LAND SOUTH OF THORNCLIFFE ROAD, LEEK

PLANNING REF: SMD/2017/0434

FURTHER INDEPENDENT REVIEW OF SUBMITTED TRANSPORT DOCUMENTATION

APRIL 2018

Figure 1: Junctions User Guide – Measurement of Minor Arm Visibility

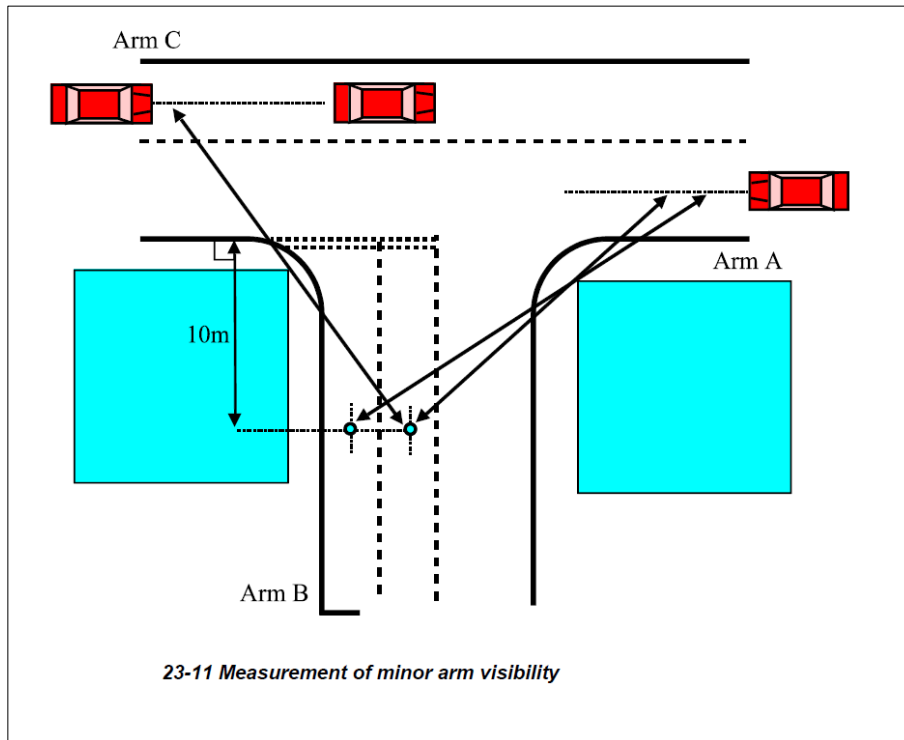
- 2.3 In our previous review we considered the parameters used to model the A53 / Thorncliffe Road junction and held concerns in relation to the inputs used in the assessment. We also referred to the guidance included within the Junctions user guide which indicates that the visibility of a minor arm should be taken 10 metres back from the give way line. This requirement is illustrated in **Figure 1**.

- 2.4 We highlighted that the visibility inputs used in the modelling exercise undertaken by the consultant were unrealistic and therefore undermined the accuracy of the results presented. Visibility on Thorncliffe Road is greatly inhibited by an existing building to the north and thick vegetation to the south. It is acknowledged that while the updated TA provides further information on visibility at the junction, the document does not address this issue as an updated assessment has not been presented. An updated assessment would be likely to show a worse operation of this junction and the we maintain that the visibility information presented should be updated in the model to ensure that a more representative appraisal of the junction's operation is considered.
